**ADDENDUM NO. 1 TO PROJECT NO. 44532**

**CONSTRUCTION WORK, PLUMBING WORK, HVAC WORK and ELECTRIC WORK  
REHABILITATE SHOWERS, BLOCKS A, B, C, D, E, F, G & H  
GREEN HAVEN CORRECTIONAL FACILITY  
ROUTE 216  
STORMVILLE, NY**

January 9, 2015

# 1 SHOWER PIPING SCHEMATIC - C BLOCK

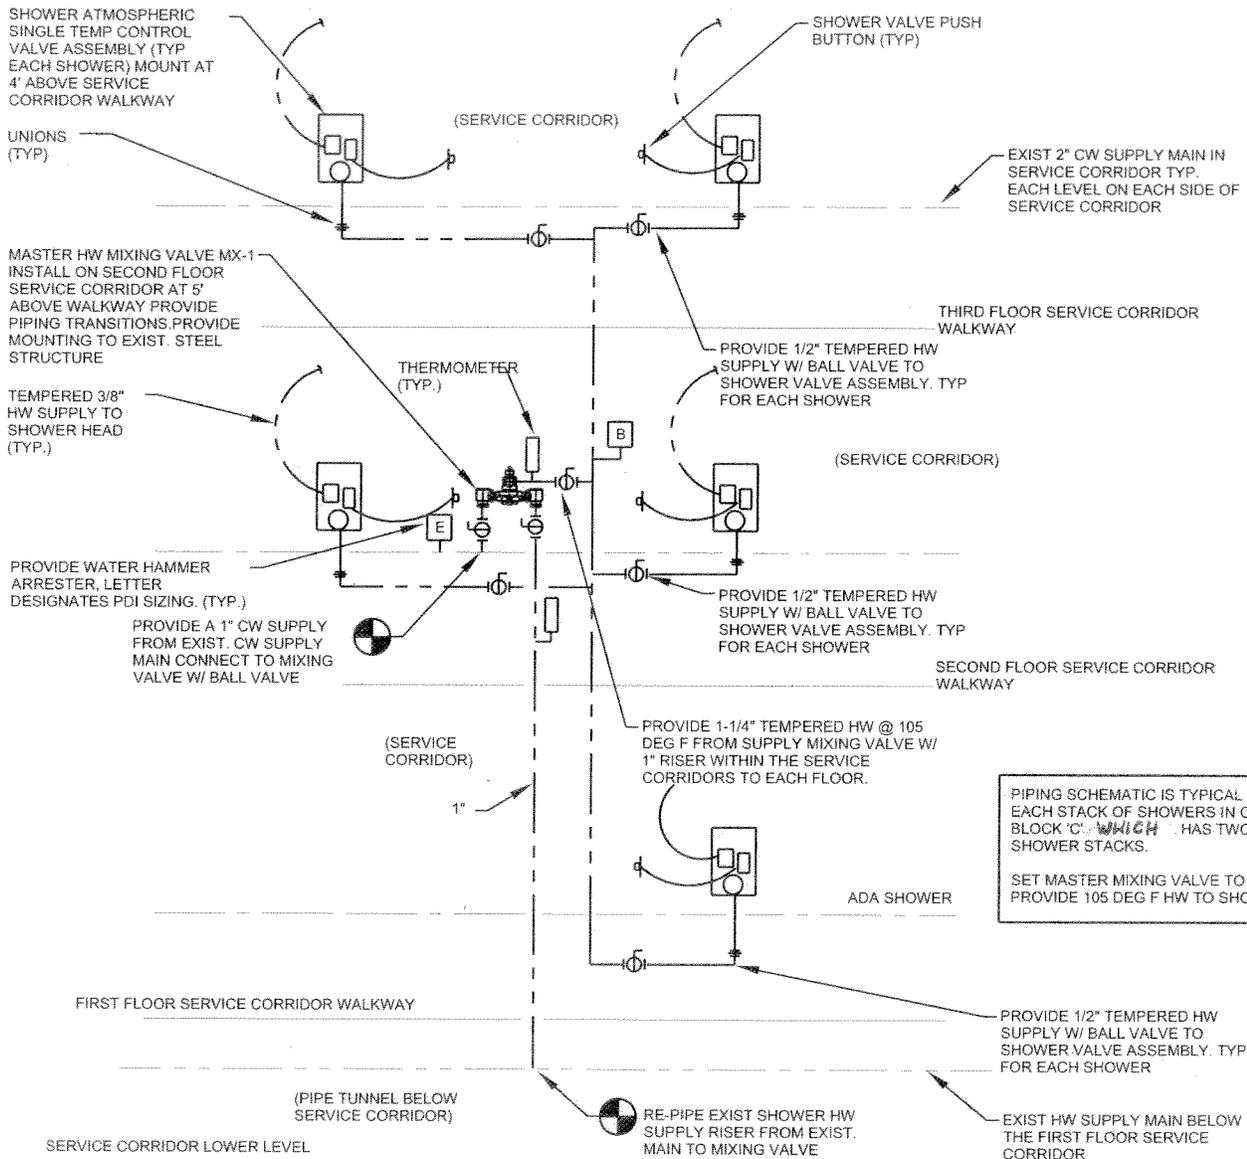
3. Drawing No. P-001 Detail 1: Delete Detail and Replace with Detail 1/P-SK1 shown on attached Drawing No. P-SK1 dated 1/7/15.
4. Drawing No. P-001: Add Detail 1/P-SK-2 shown on attached Drawing No. P-SK2 dated 1/7/15.
